Service Note		
Product	Description:	Service note no.
VoiceLive Touch 2	USB audio problem	SNo-T0179

On the first batch of VoiceLive Touch 2 we have seen cases with USB audio problems.

VoiceLive Touch 2 bottom view

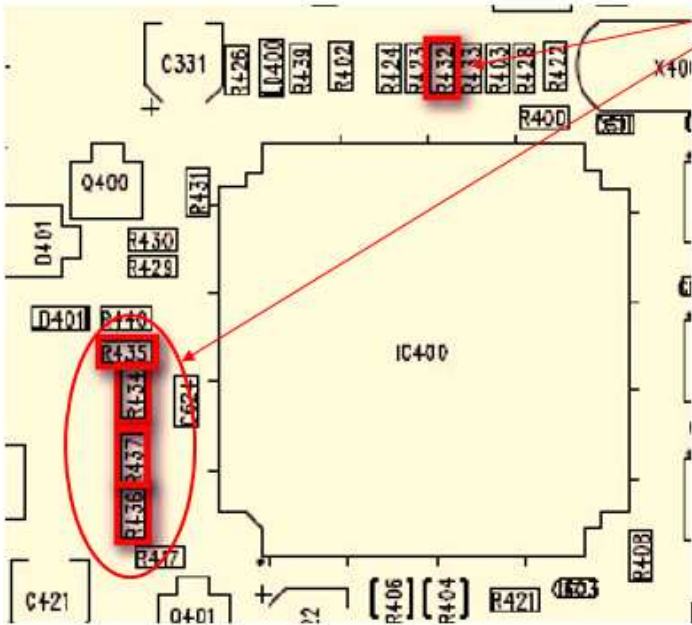
On the bottom side R513 and R514 must be changed from 1 kohm to 82R5

VoiceLive Touch 2 top view

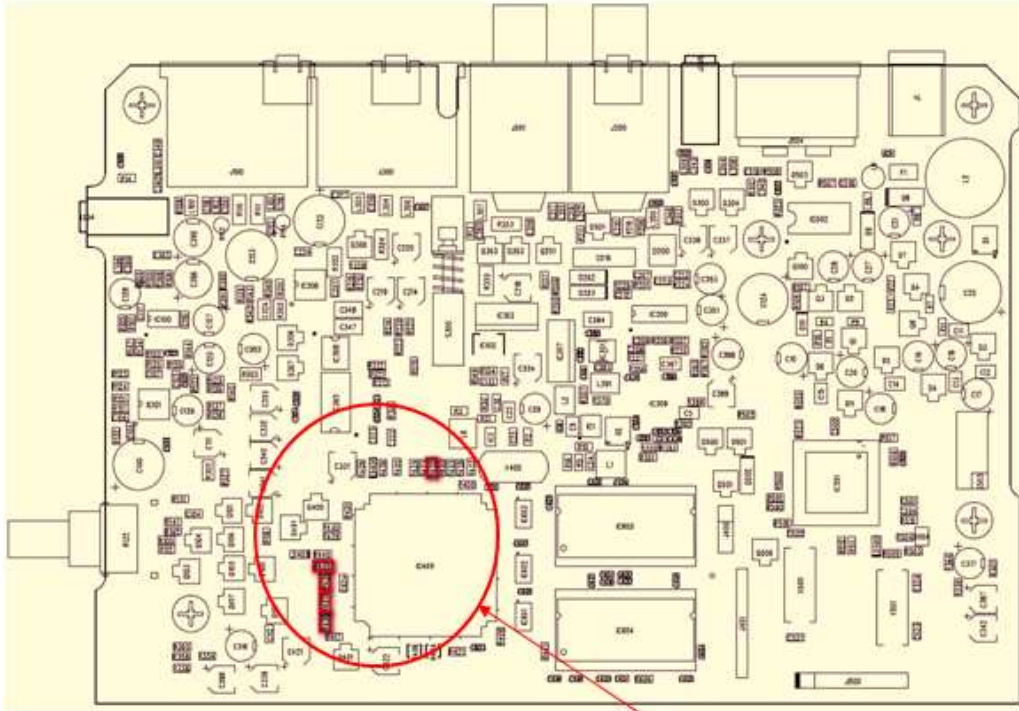
On the top side R432, R434, R435, R436 and R437 must be changed from 1 kohm to 82R5
